RE: Bloomfield Refining Company
#50 County Road 4990
Bloomfield, New Mexico
EPA ID No. NM089416416
Administrative Order on Consent - Docket No. VI-303-H
Response to USEPA Comments on the Draft RFI/CMS Report

**RESPONSE TO USEPA COMMENTS ON THE 11/08/94 DRAFT RFI/CMS REPORT
BLOOMFIELD REFINING COMPANY**

FIGURE 8

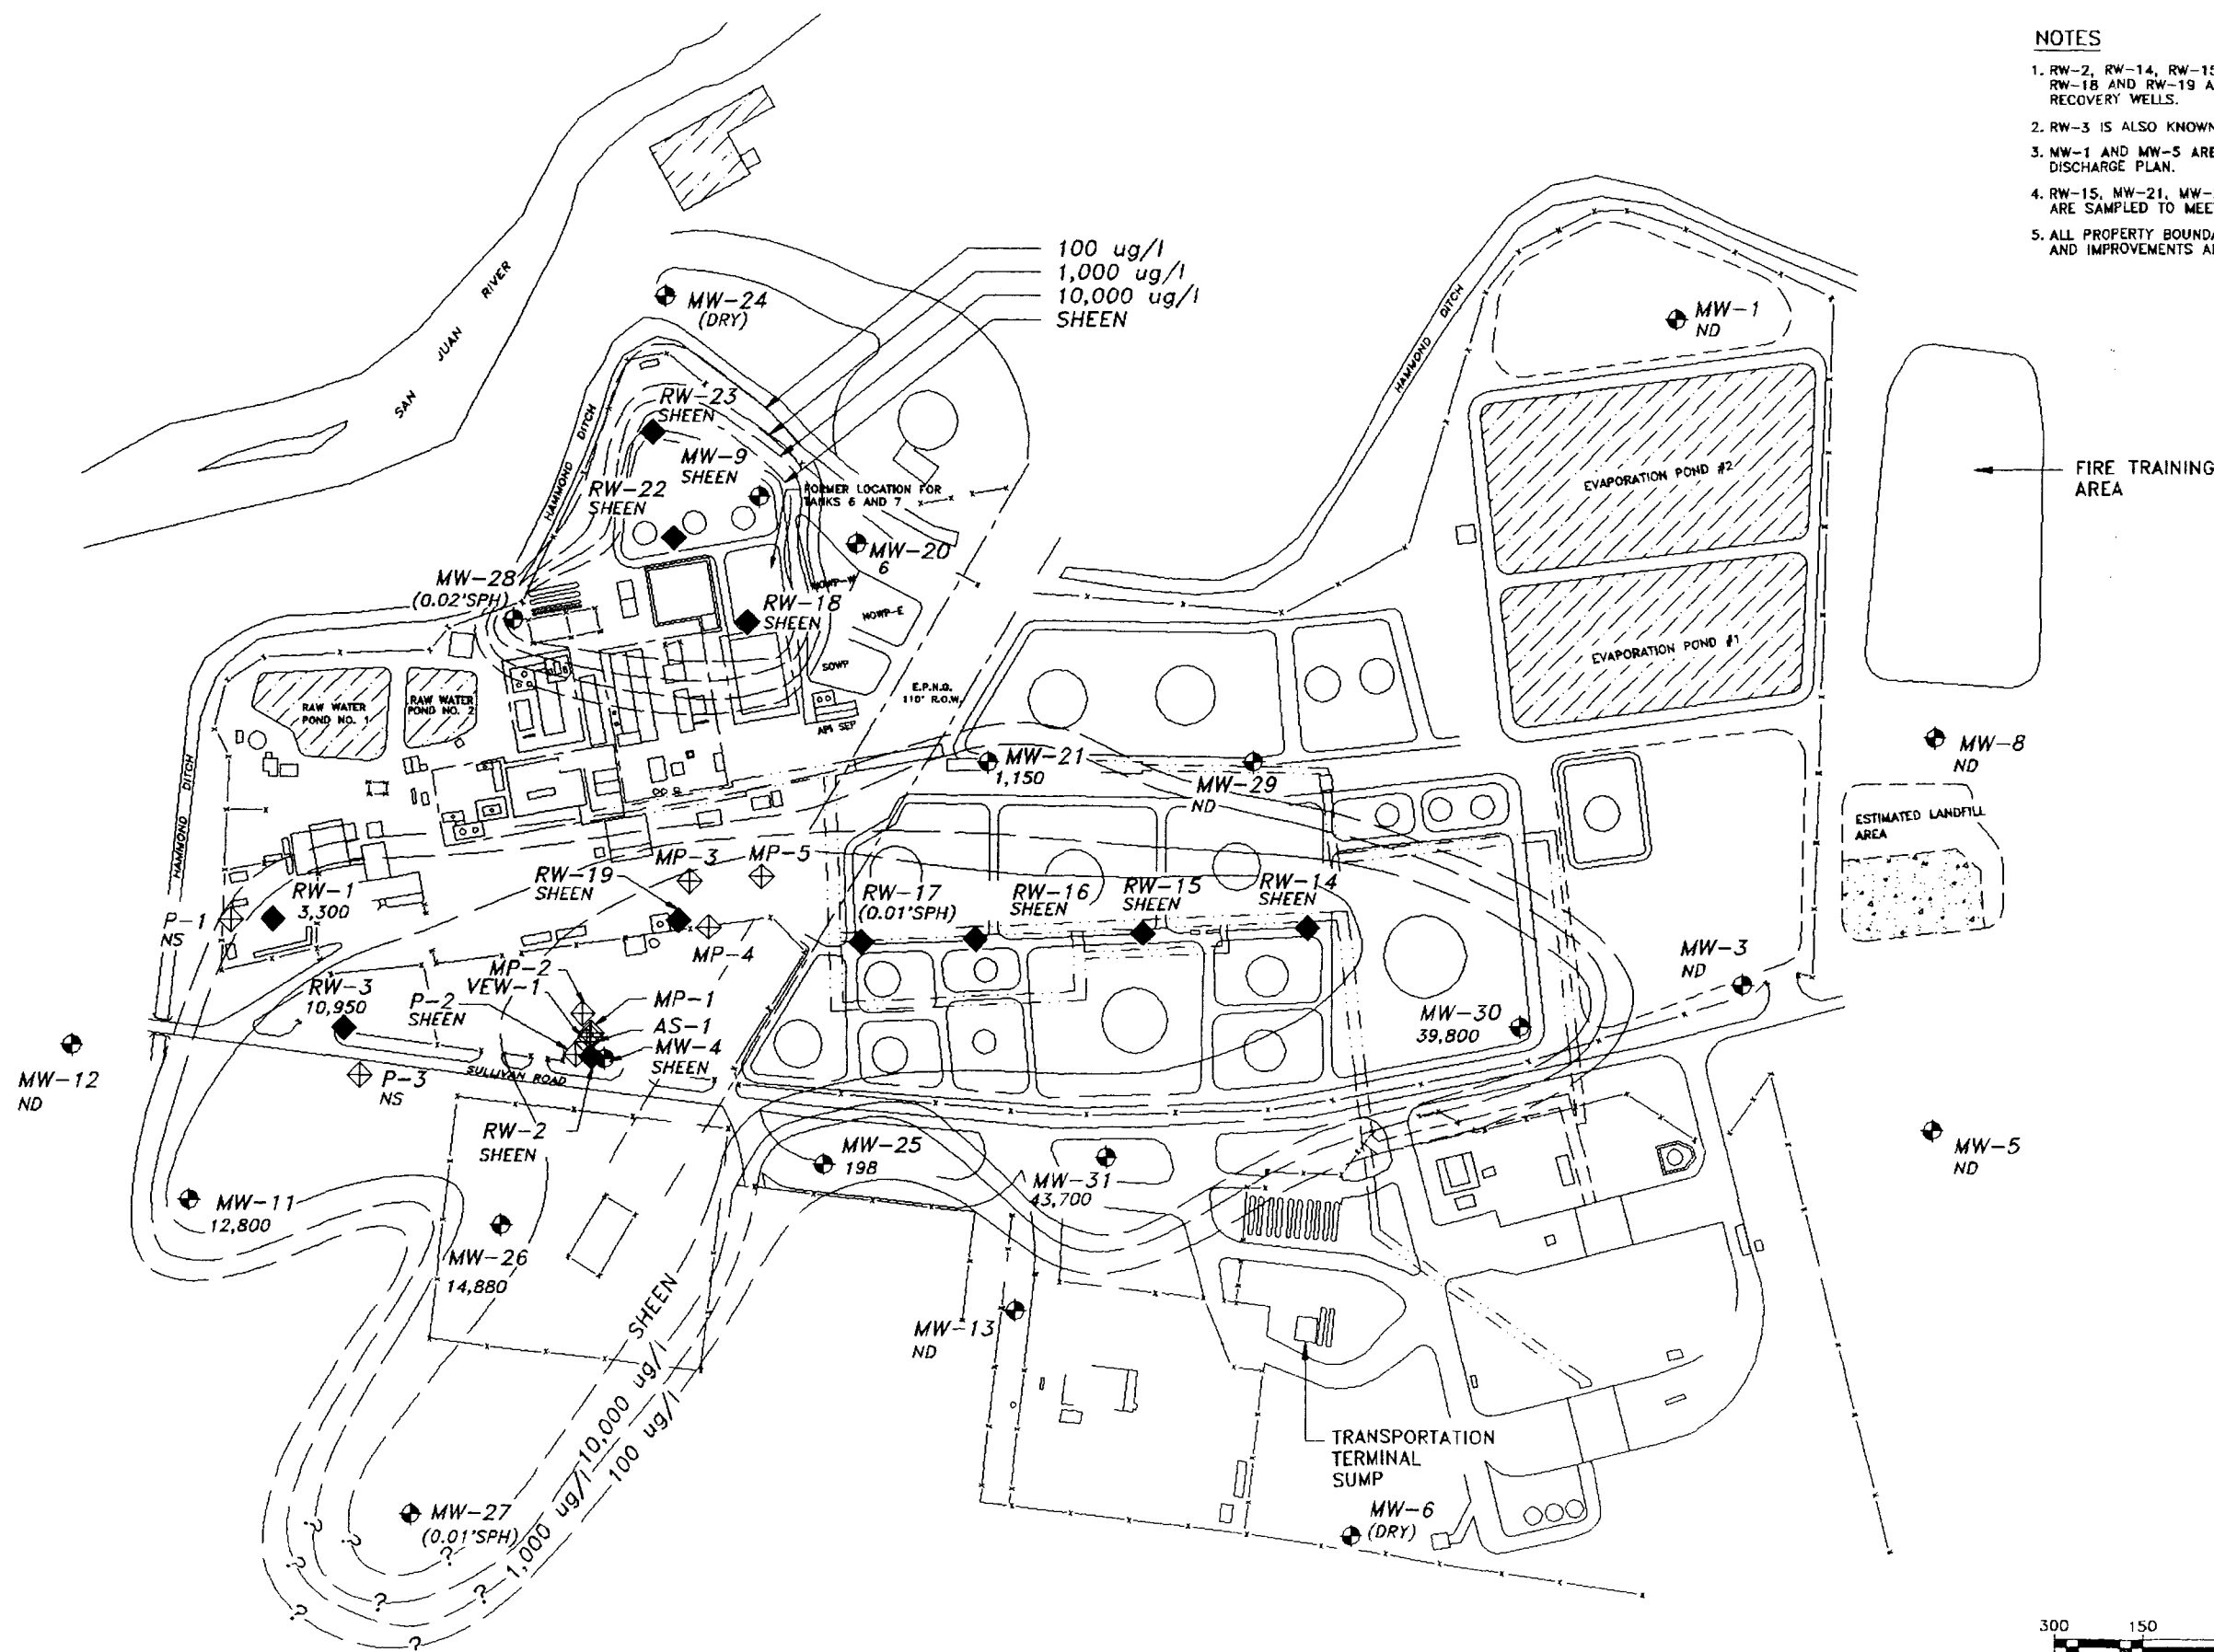
The draft RFI report does not contain any thickness maps showing the limits of groundwater contamination. These maps must be compiled to show the limits of groundwater contamination across the facility as well as off-site.

Figures 4, 5, 6, 7, 8, 9, and 10 depict the extent of SPH, total targeted volatile organics, and total targeted semi-volatile organics, based on the May 24-25, 1994 monitoring data and the August 3-4, 1994 monitoring data. The maps show two main areas of hydrocarbon contamination. Dissolved hydrocarbon and SPH plumes are present along much of the south side of the facility extending southwest along the El Paso Natural Gas pipeline. The levels of SPH in this area are currently controlled by a number of recovery wells. Three additional monitor wells have been installed southwest of the site and plume definition is essentially completed with these wells (the results will be forwarded to USEPA before 1 May 1995). In the northwest corner of the site, another area of hydrocarbon contamination is present. In this area, a thin accumulation of SPH has been identified.

04/05/95	3014BL (1:100)		
PROJECT NO.:	CONTRACT:		
023353014			
DRAWING:	REVISION:		
FIGURE 10

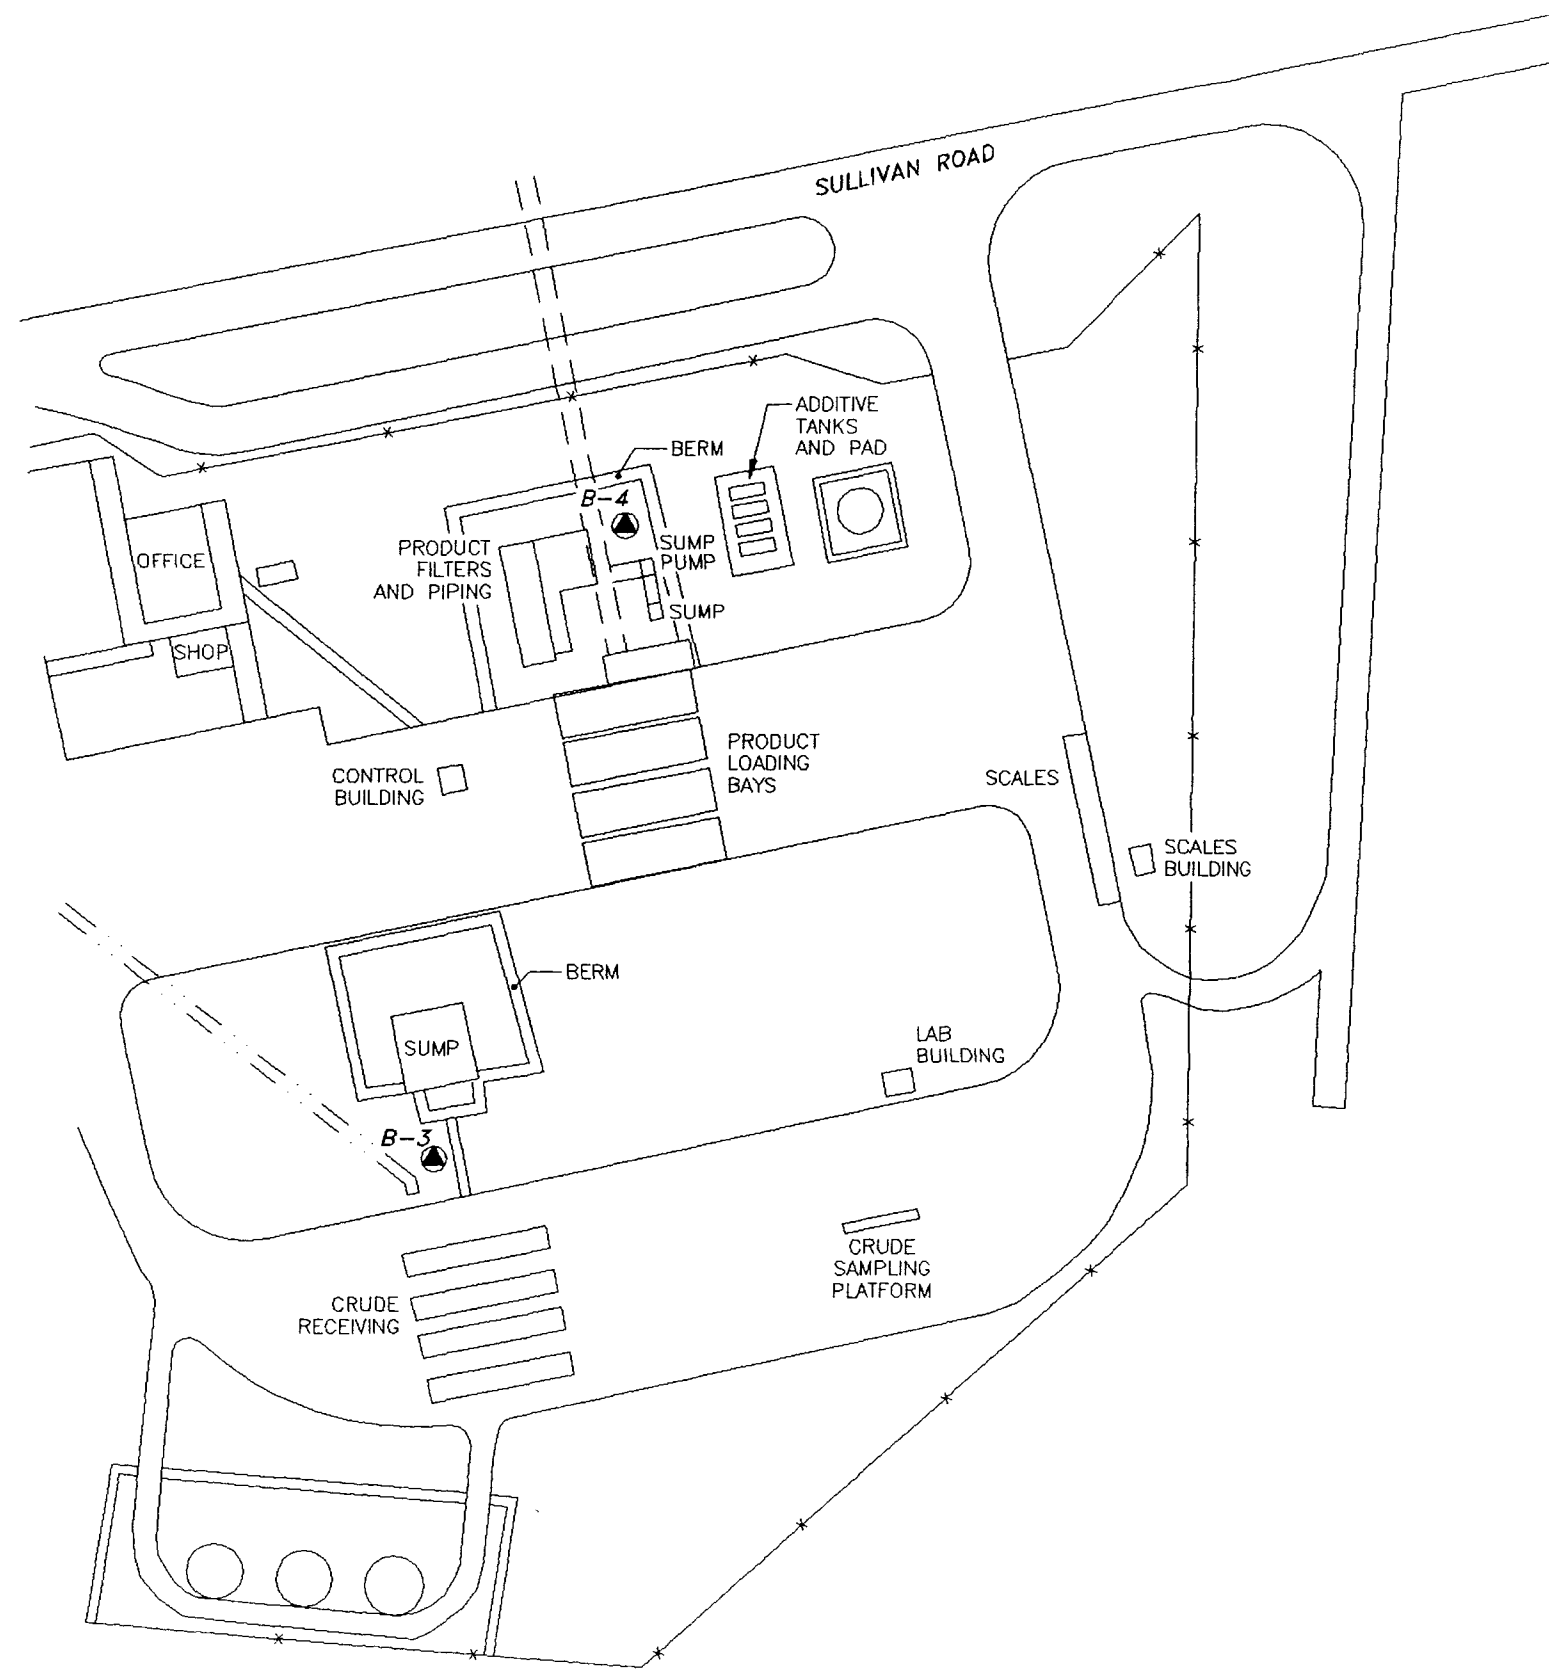
These concentrations indicate that there has been a release to the environment. The full extent of the release must be therefore delineated. The location of the two borings with respect to the loading operations must be presented in greater detail. Are the two borings near the loading area, or are they located near the boundary of this SWMU? Additional information will be required in this area prior to determining no further action. The rationale for not fully delineating the release from this SWMU must be presented.

Response: Figure 10 shows the locations of soil borings B-3 and B-4. Soil boring B-4 is located near the sump pump approximately 50 feet from the product loading bays (the most likely location of a release). Soil boring B-3 is located within 50 feet the crude oil receiving area and the pipeline that extends from this area. Had significant releases occurred in these areas, the borings would have detected some evidence of these releases. Instead, the hydrocarbon concentrations in this area are near method detection limits and unlikely to represent a threat to groundwater through leaching. The hydrocarbon levels in the samples collected from B-3 and B-4 are believed to be the cumulative affect of product handling/ incidental spillage in this area and do not suggest that additional assessment is needed in this area.

DESIGNED BY: CD	DETAILED BY: EF	CHECKED BY:
DATE:	FILE: BL-WELL LOC	
PROJECT NO.: 023353014	CONTRACT:	
DRAWING: FIGURE 11	REVISION:

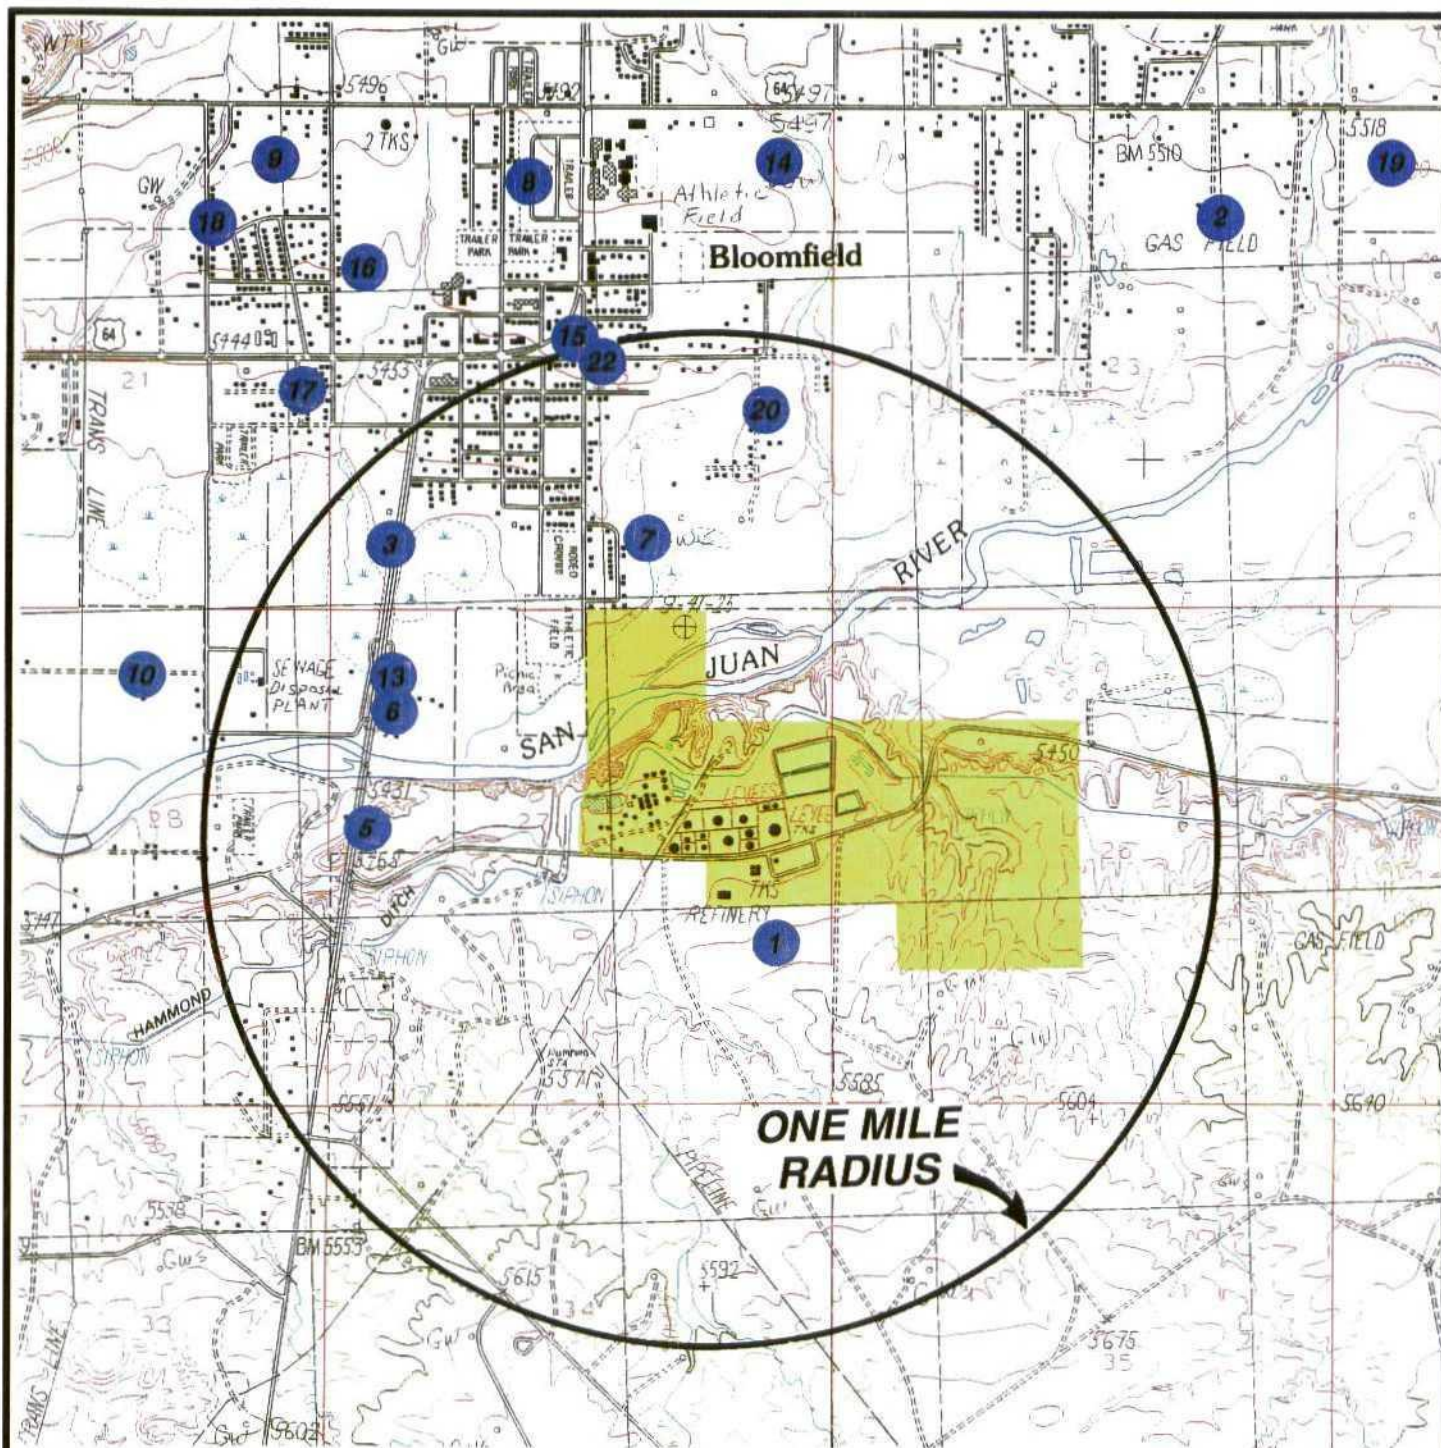
According to the draft RFI report, two off-site private wells (Looney well and Brown well) are located downgradient of the facility in the shallow aquifer. The RFI report does not provide any information on the water quality of the off-site wells. Have either of these wells been sampled to determine if they have been impacted by facility operations? Additional information on these two wells must be provided in the RFI report.

Response: Figure 11 in this submittal shows the revised water well locations within a one mile radius of the BRC facility using the New Mexico township-range-section coordinate system. Well locations were incorrectly plotted in the original RFI report. Copies of the well logs are provided in Attachment D. As shown on the revised map, the Brown well (#5) is located on the north side of Hammond Ditch near Highway 44, more than 2,000 feet from the southwesternmost corner of the BRC facility. The Looney well (#6) is located north of the San Juan River, also near Highway 44. The revised, correct locations of these wells indicate that they are not at risk of hydrocarbon contamination from the BRC facility.

Well Log for MW-12

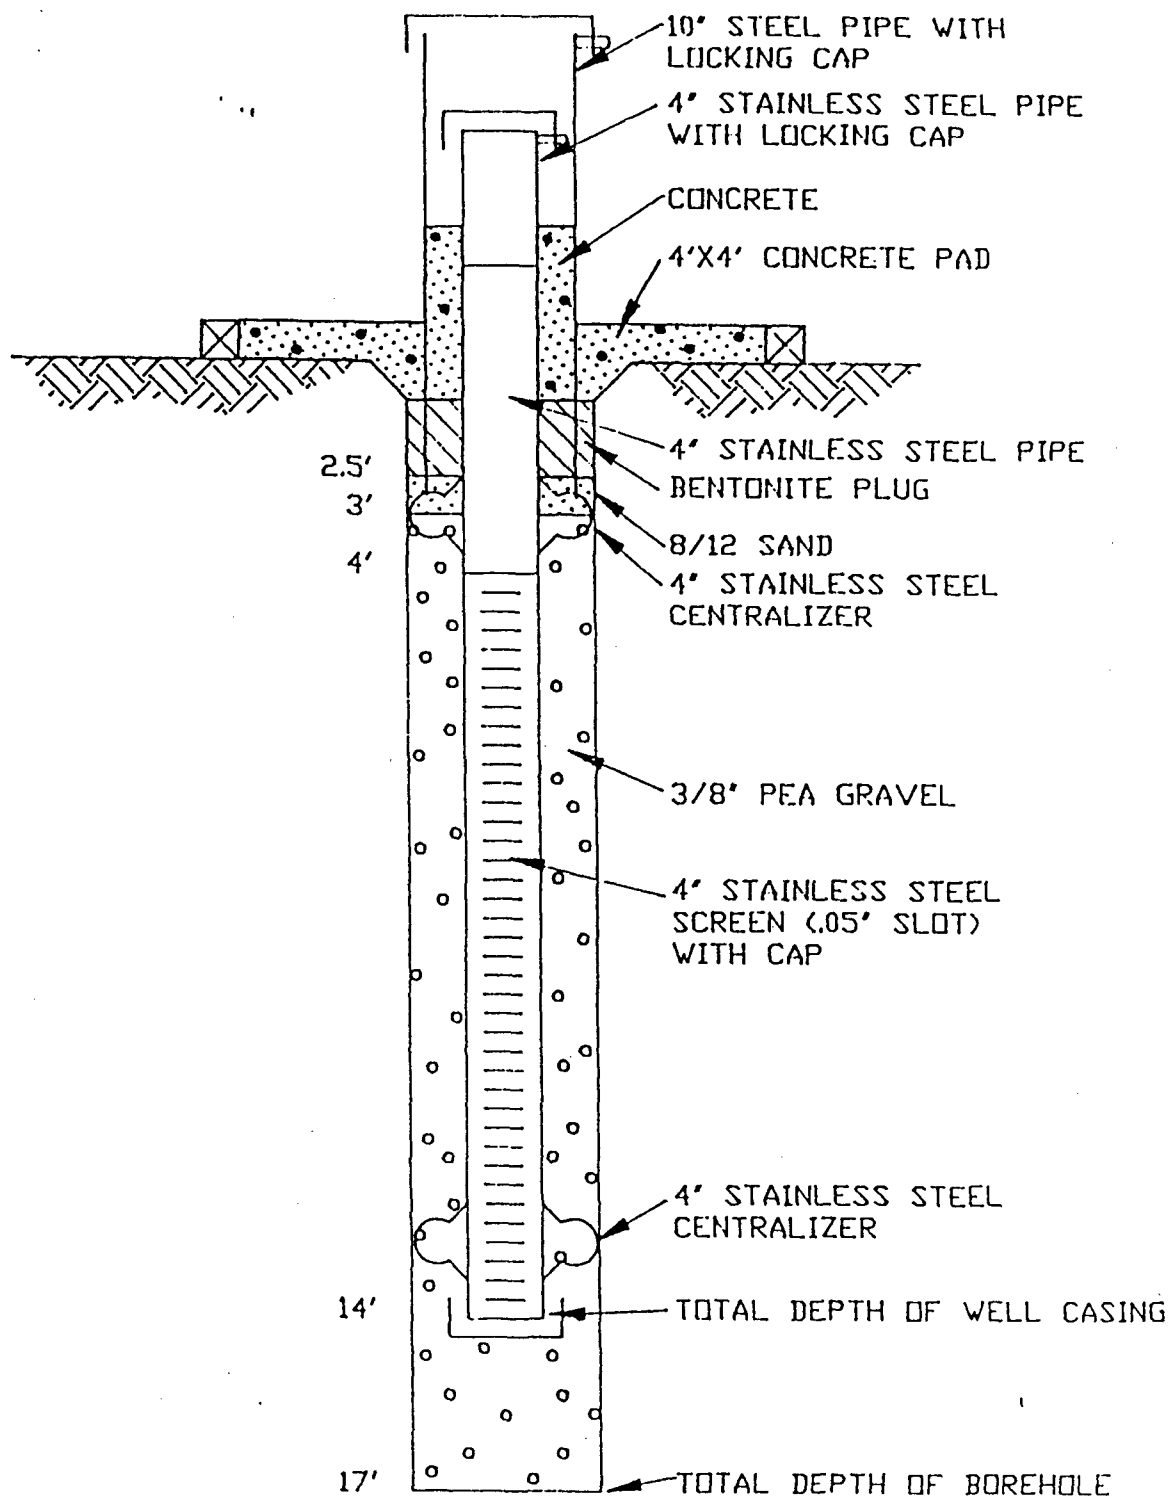
The potentiometric level in monitoring well MW-12 is approximately 10 feet below the potentiometric level in the nearest well. The draft RFI report does not discuss or explain the reasons for this extreme difference in the water levels. Is this well monitoring a different water-bearing strata? If so, which aquifer? A discussion on monitoring well MW-12 must be provided in the RFI report.

Response: Attachment B contains a copy of the well log for monitoring well MW-12. Well MW-12 is a relatively shallow well. The borehole extended to 17 feet and the screen was installed from 4 to 14 feet which extends to the top of the Nacimiento Formation. The elevation

of the top of bedrock in this area is approximately 8 feet lower than in nearby monitoring well MW-11. Since the perched aquifer follows the bedrock contour, groundwater elevations are also lower in this area than in other site wells.
